Technical Bulletin

Model 1405

Contact Corrosion Ambient Temperature/RH% Sensor Cable & Intermittent Missing Ambient Temperature Faults

Rev 09/2012

Corroded Contacts

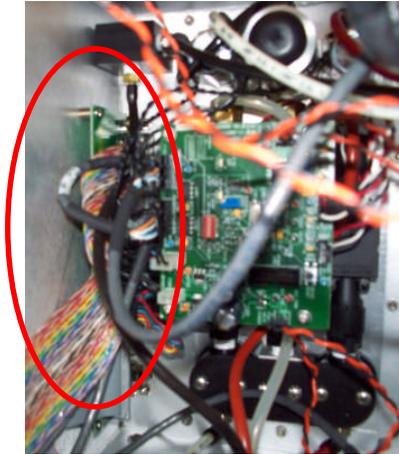
2. If you are experiencing issue with intermittent signal loss or a failed temperature reading you should open the connection at the inlet area and check for corrosion on the contacts. If corrosion is present you should replace the cables.

Rear Interface Board

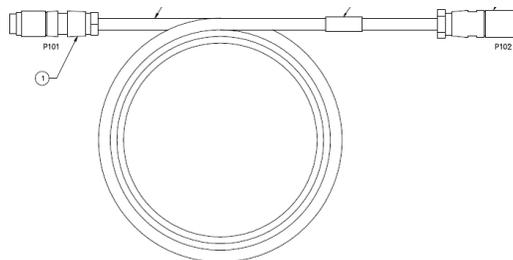
1. If the instrument reports intermittent faults of the ambient temperature sensor open or missing; the temperature reads -273C and you have confirmed it is not related to the corrosion issue above; you may have an impedance issue on the rear interface board.
2. The board is located inside the electronics compartment in the rear left corner or to the left of the mass flow controller assembly. The board should be replaced to resolve the impedance issue.
